## Secure 2<sup>nd</sup> Row Seat Latching Cables

**Classification** Campaign Bulletin    **Section/Group** 13 - Seats    **Country/Region** United States

**Year** 2016    **Model** Model X    **Version** All

Figure 4 (Latching cables highlighted)

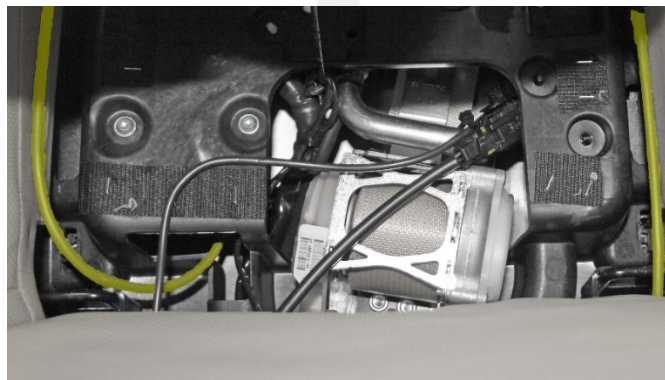
2. Identify the seat latching cables (Figure 4).

**Figure 5 (Latching cables highlighted)**

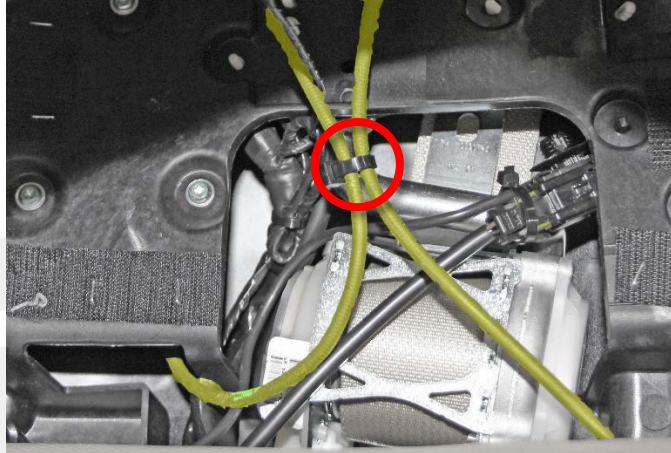
3. Gently pull both latching cables toward the center of the seat, then use a cable tie to loosely secure the latching cables together (Figure 5).

**⚠ CAUTION:** Do not fully tighten the cable tie.
